CITY OF  
**West Linn**

Subject: Appellant Packet Received for AP-21-02

# APPEAL of Conditional Use Permit

Re: Willamette Neighborhood Association Appeal Packet for AP 21-02  
*Appeal of Planning Commission Decision Athey Creek Middle School Conditional Use  
Application at Dollar St., File No.  
CUP-21-02/DR-21-04/WRG-21-02/MISC-21-04/VAR-21-01/VAR-21-06/LLA-21-02  
Hearing Date October 4, 2021*

FIGURE 10: SCHOOL SAFE ROUTES TO SCHOOL AND WALKING BOUNDARY

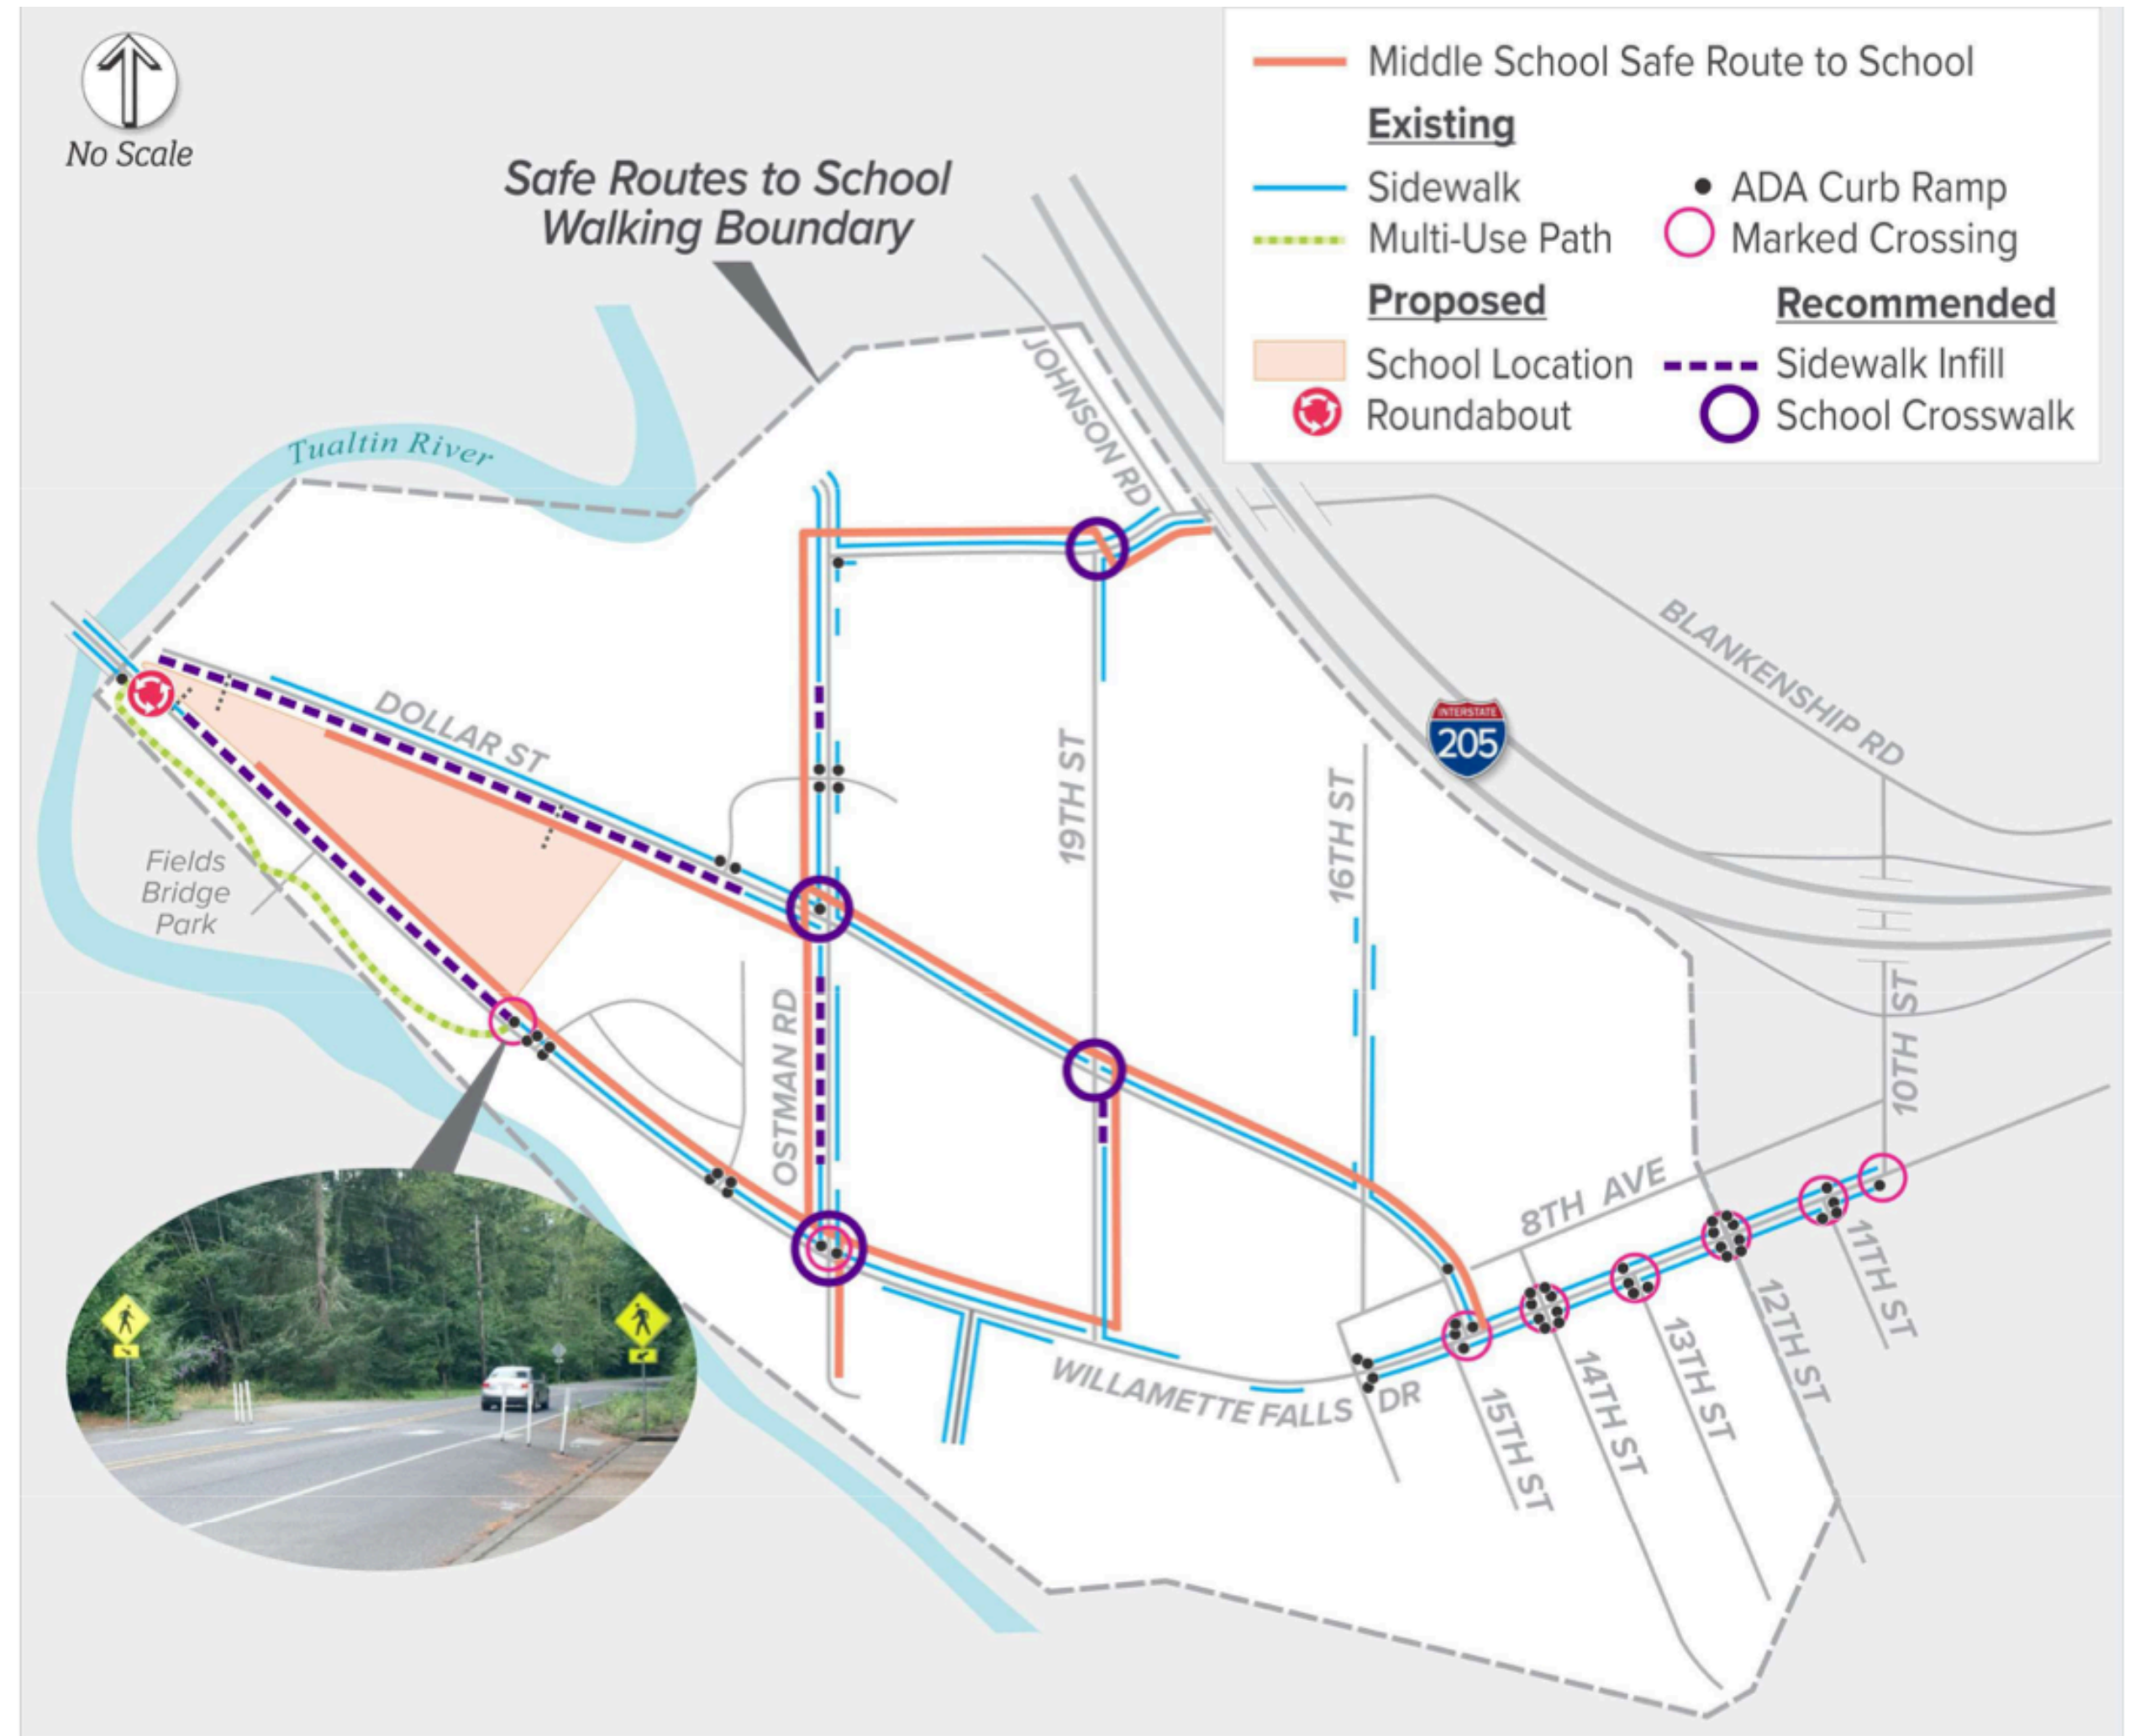
# Inadequate WALKING infrastructure

Lack of sidewalks, steep hills on streets connecting to Safe Routes

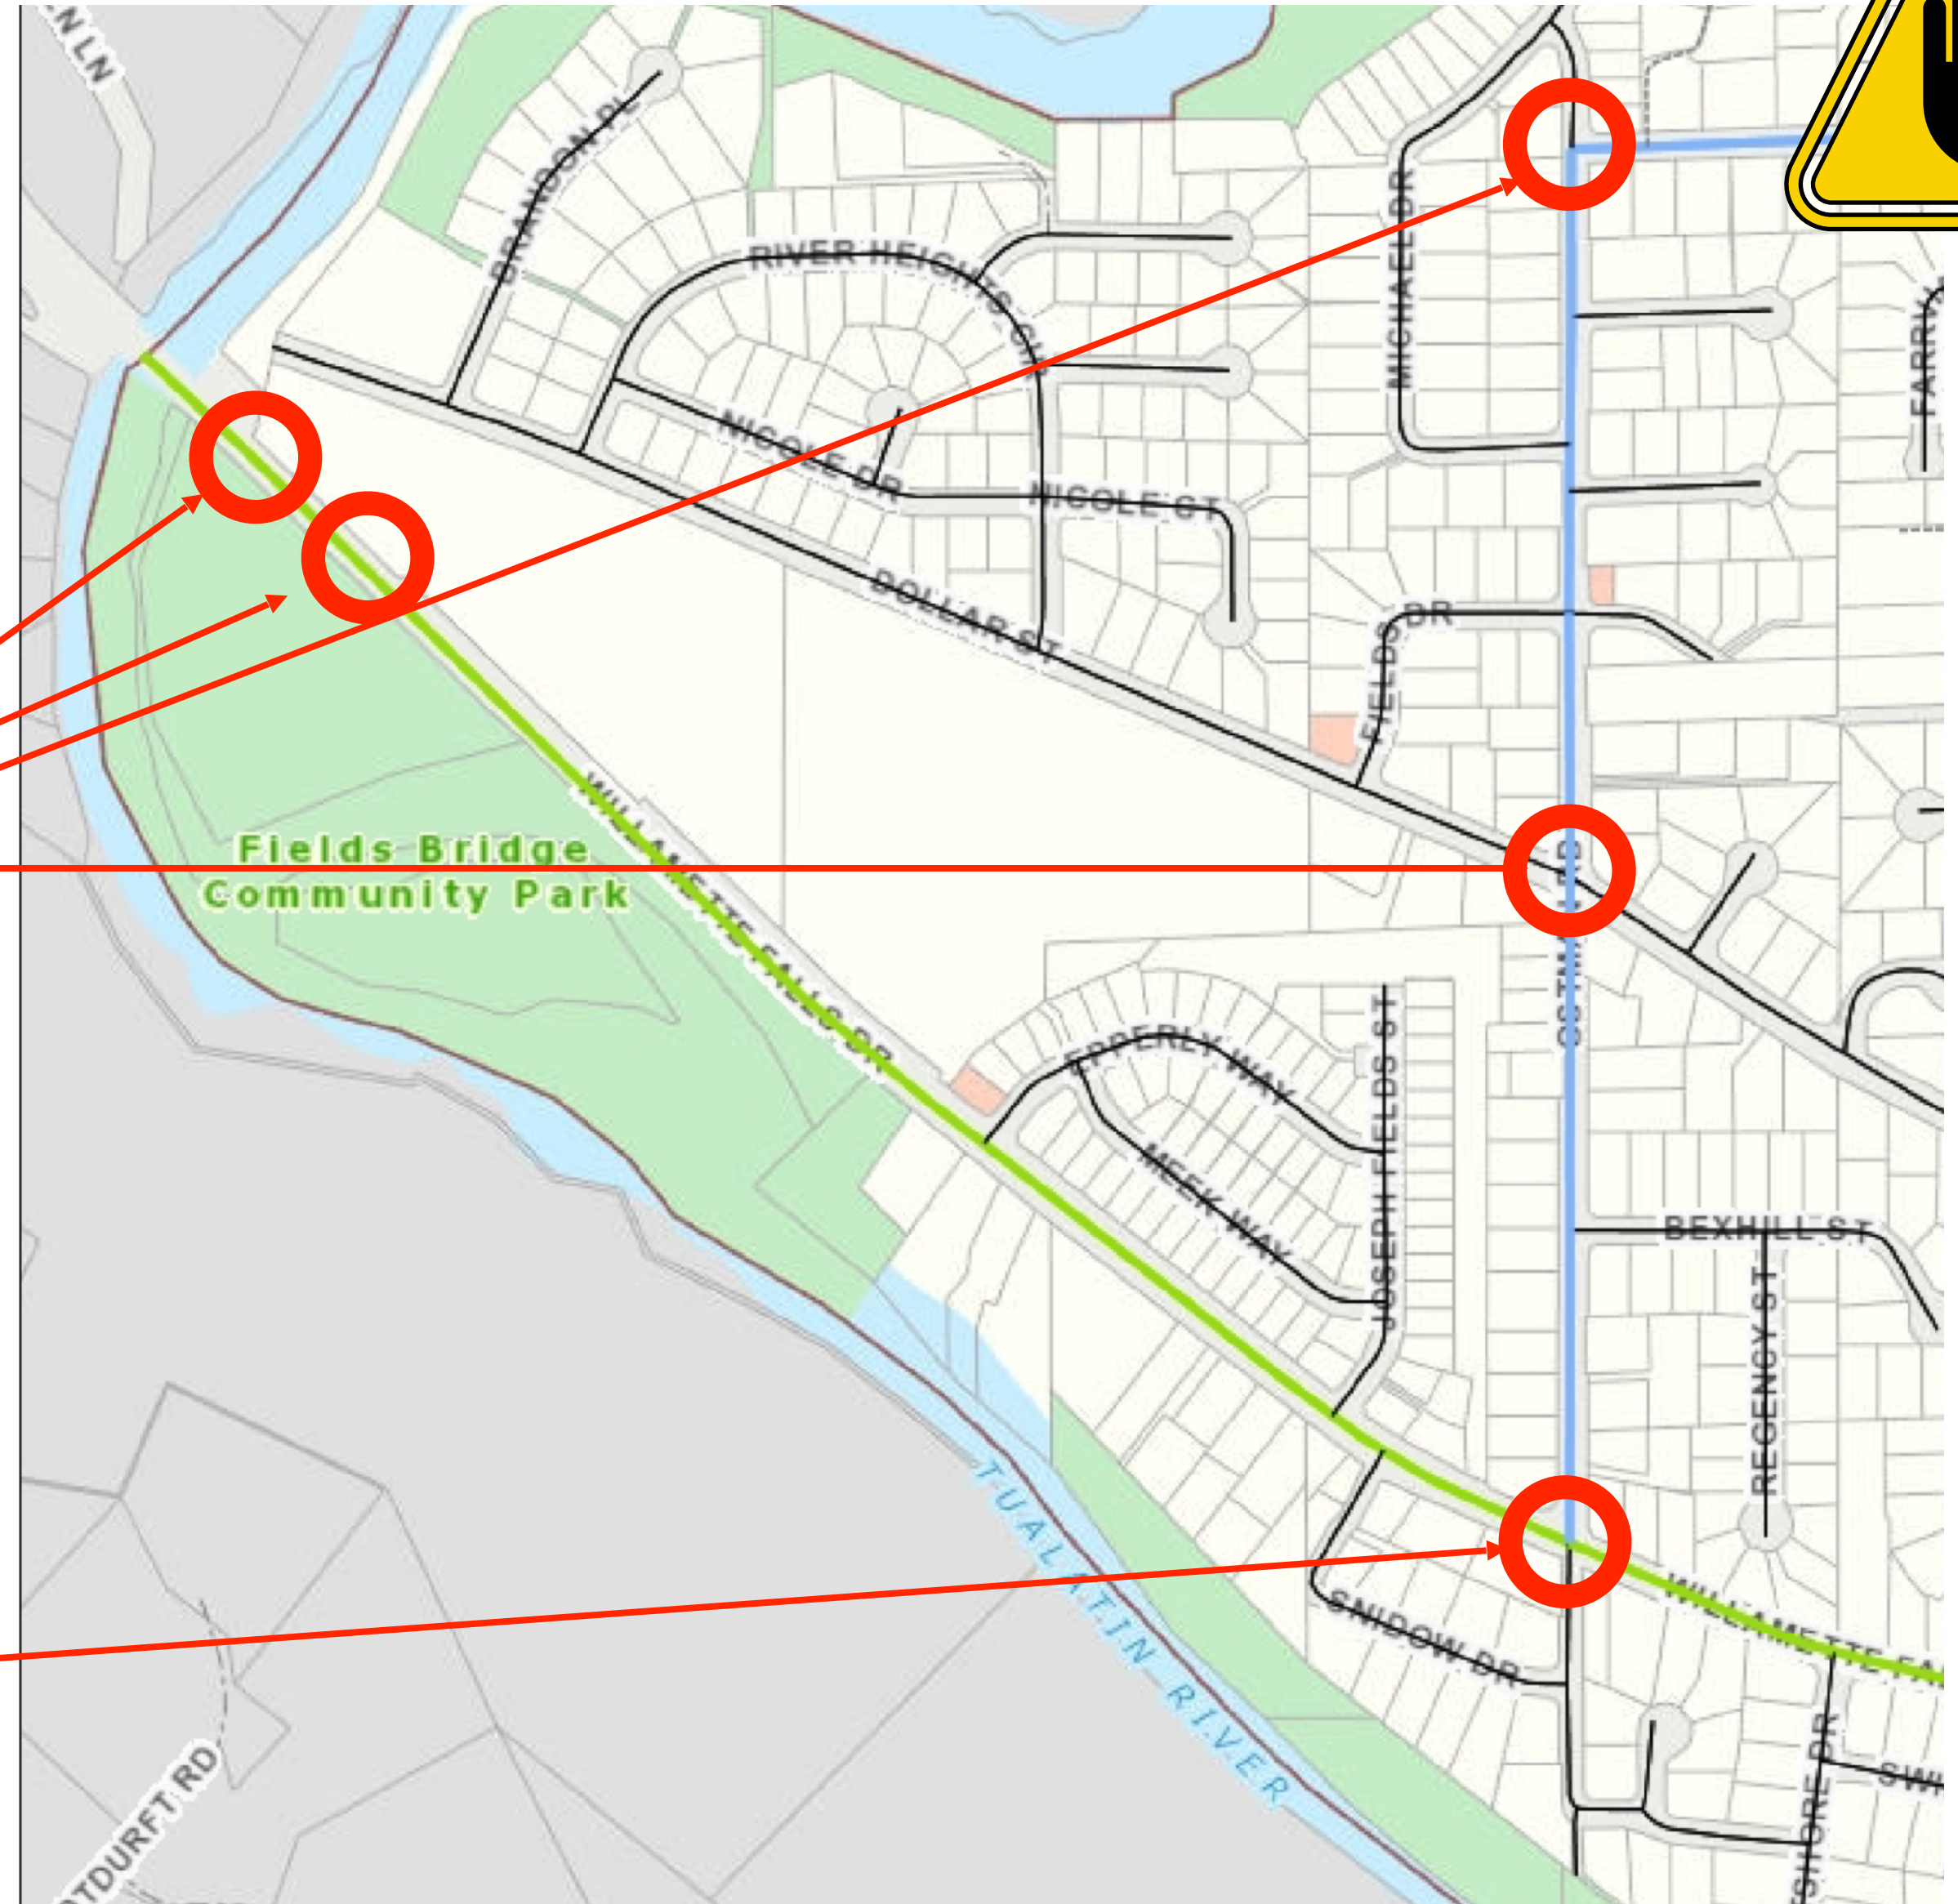
New bottlenecks on path to school via Local streets that can't handle the added traffic

New bottlenecks

FAILs in 2023

Intersections are required to meet the City of West Linn standard for an unsignalized intersections to operate at or below LOS D. (Highway Capacity Manual, 6th Edition, Transportation Research Board, 2017.)

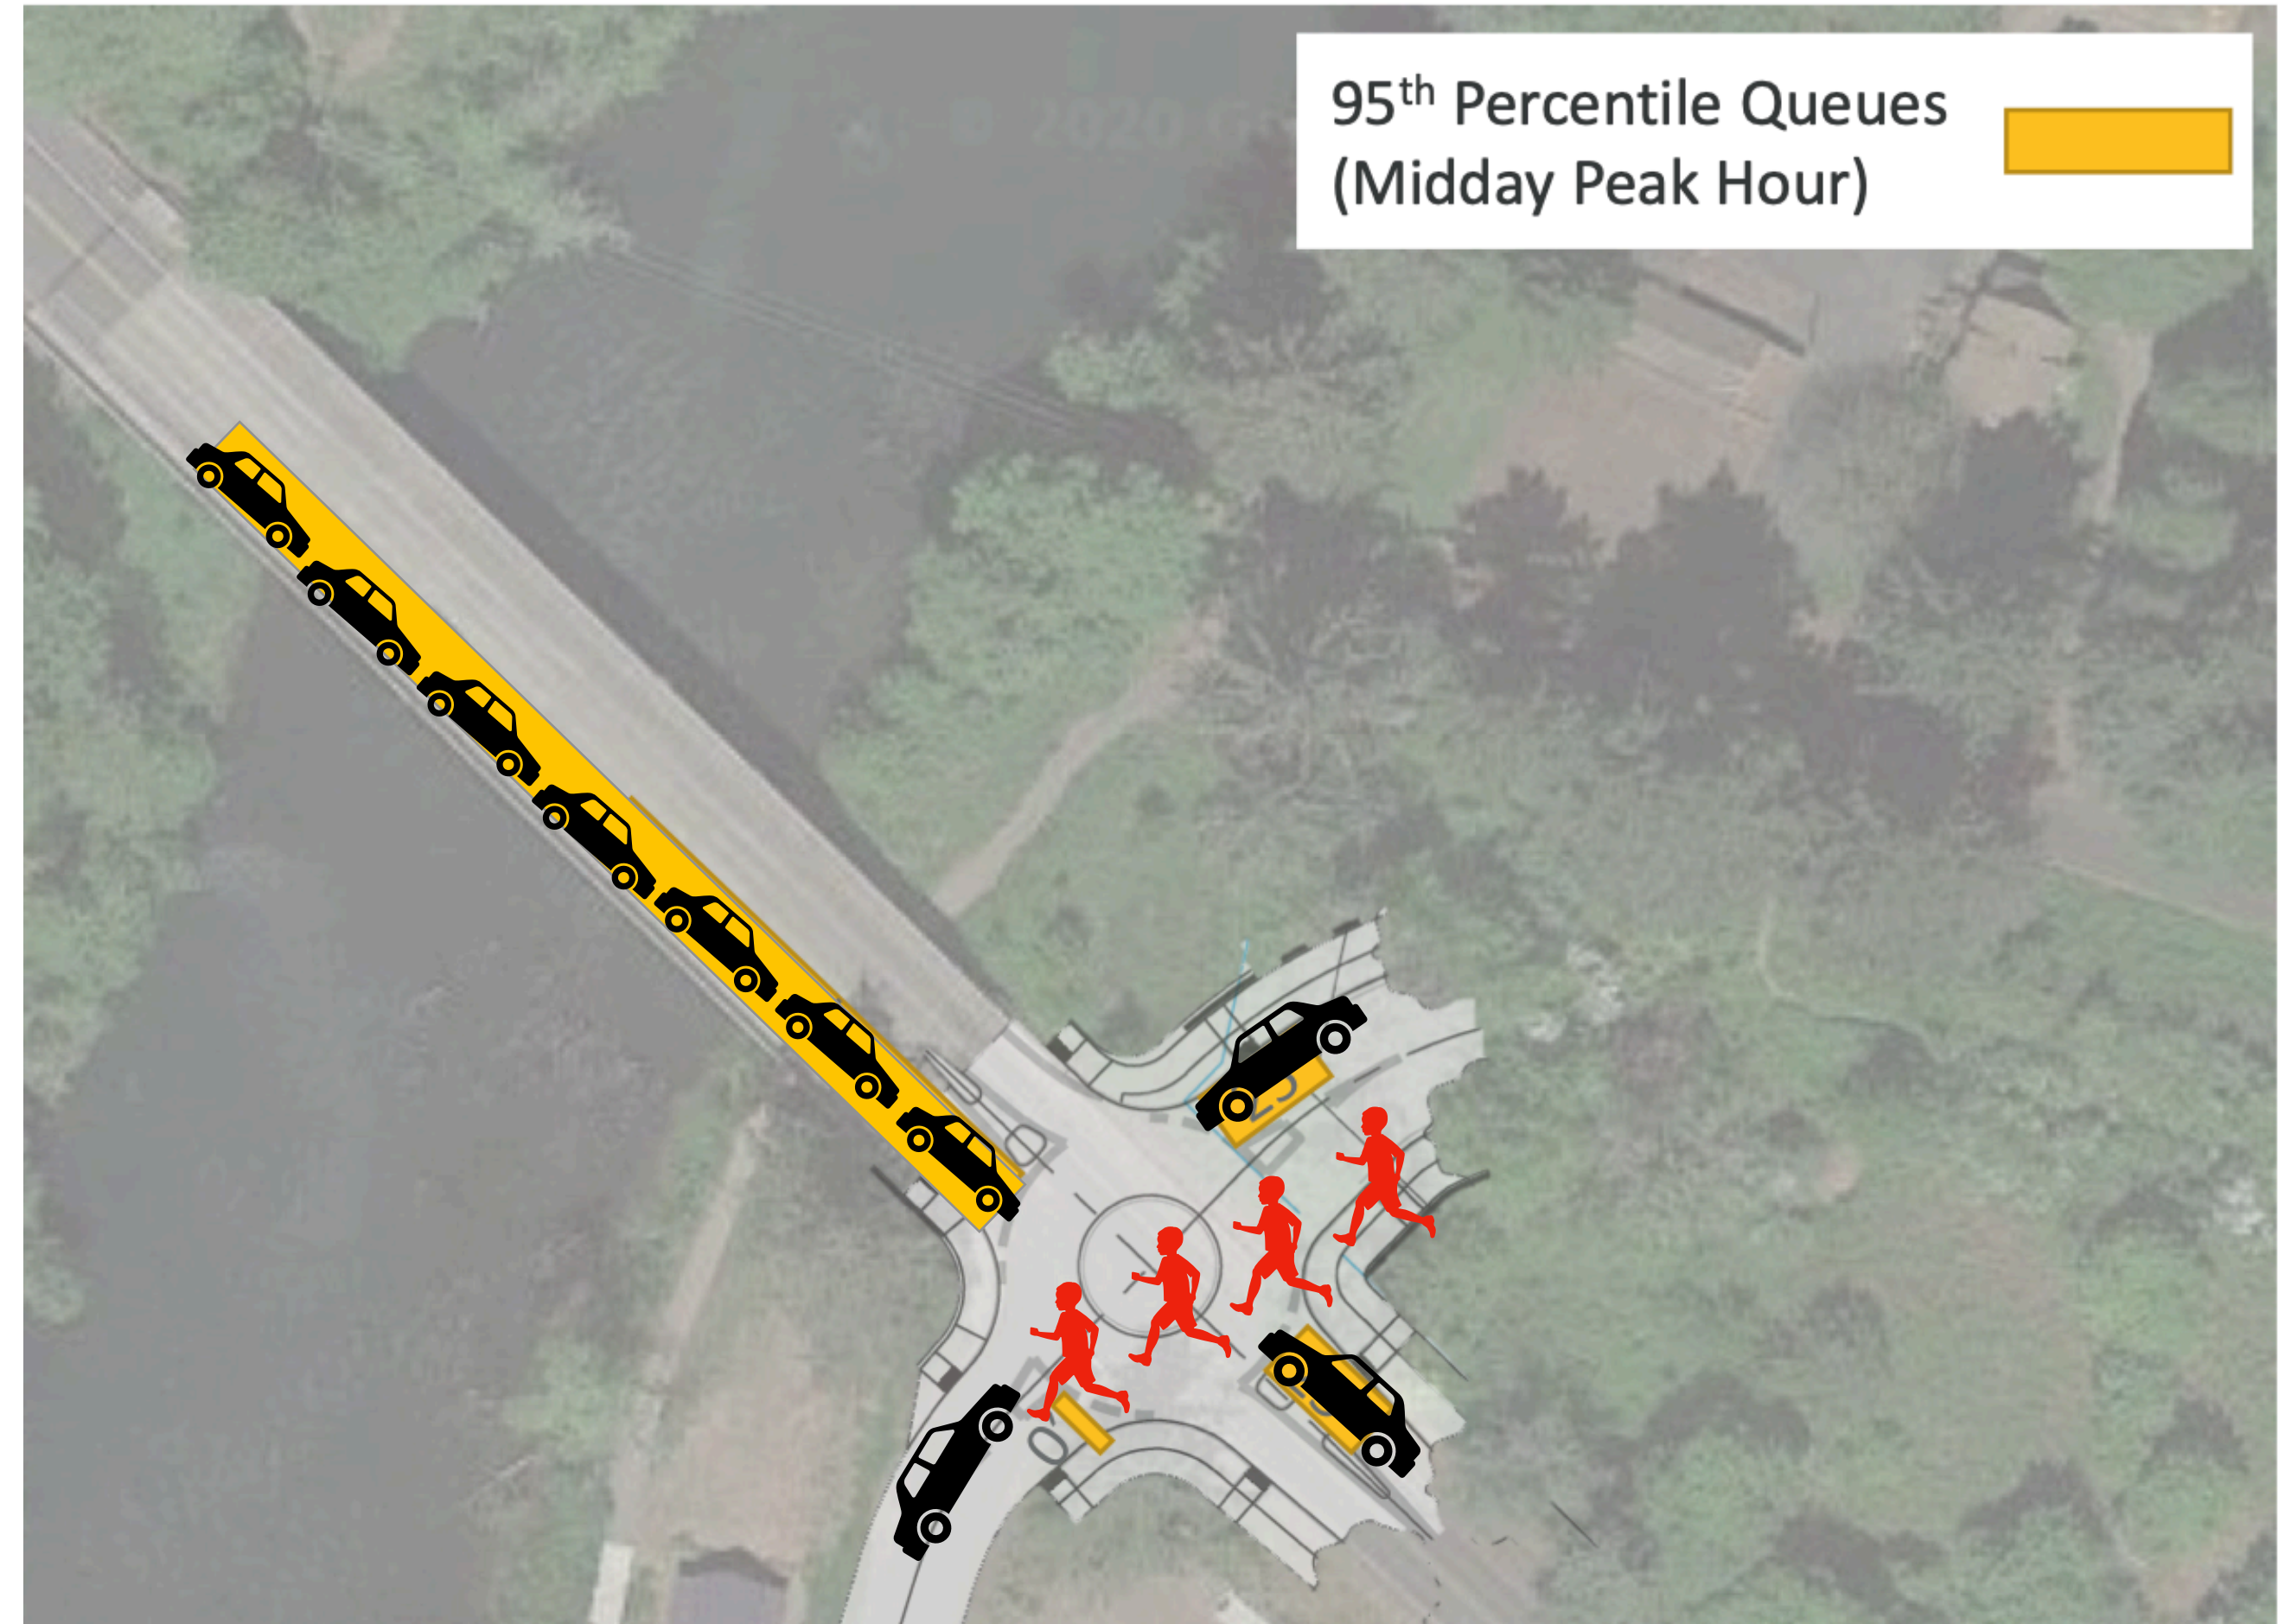
# Safety & Congestion on Bridge Roundabout

DKS estimates midday peak hour of at least 7 vehicles queue extending on to bridge
